FIELD SERVICE BULLETIN

FSB Number: LVCCFSB2006-84
Author: Tony Bryan
Date: March 20, 2006
Total No. of Pages: 3
Subject: GSM PEBL U6 – Low/Distorted Microphone Audio
Phone Models: GSM PEBL U6
Level of Repair: 2

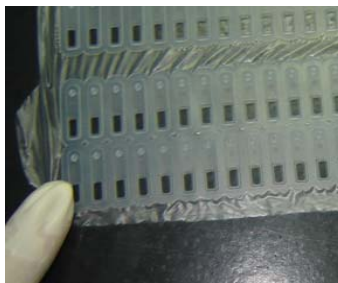
Service is aware of an issue on some GSM PEBL U6 phones, identified during the NPI Analysis, which affects Microphone Audio. Some units, returned with customer complaints related to “Low/Distorted Microphone Audio”, were found to have a problem with the Microphone Grommet (0588611Y02) placed underneath the keypad. Analysis revealed that plastic material was blocking the acoustic opening of the grommet preventing audio to the microphone. Factory Quality Team identified two root causes for this type of failure.

Root Cause #1 - No hole in grommet caused by grommet supplier not properly cleaning up burr from grommet.

Root Cause #2 - The clear acoustic mesh adhesive liner was not removed by operator at factory assembly when assembled into housing.

Before Improvement

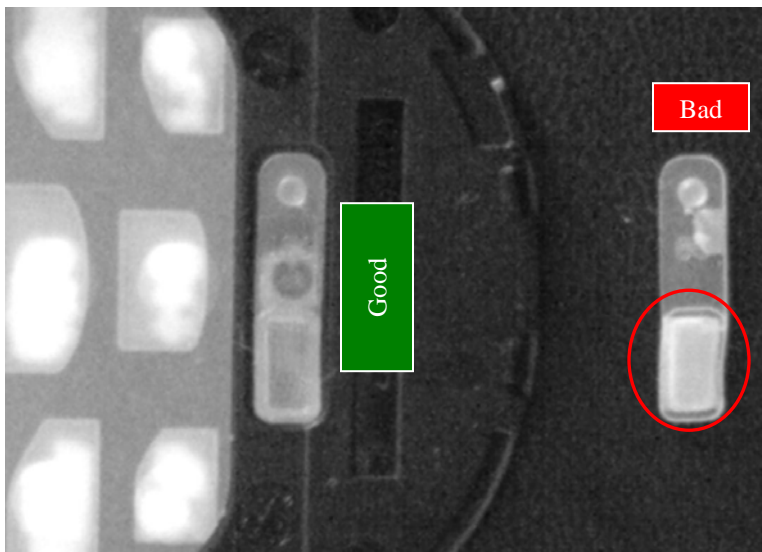
1a. Grommet Supplier “MingShun” modified their inspection process for grommet hole to implement a black background instead of by using white background, which can easy for detect the bad one. 2/7/2006 Please refer to the pictures below.

1b. Foxconn Factory implemented a 100% check the grommet hole before adhesive it into the housing, and make it as a critical inspection point in final inspection. 2/7/2006

2a. Foxconn Factory has implemented a 100% inspection check for the acoustic mesh adhesive liner peeled off or not before assembly into the housing. 2/7/2006

2b. Mesh Supplier 'FZ' changed the color of the acoustic mesh adhesive liner and does not use clear liner. This allows for easier inspection to determine if the liner has been peeled off or not during assembly into the housing. 2/15/2006
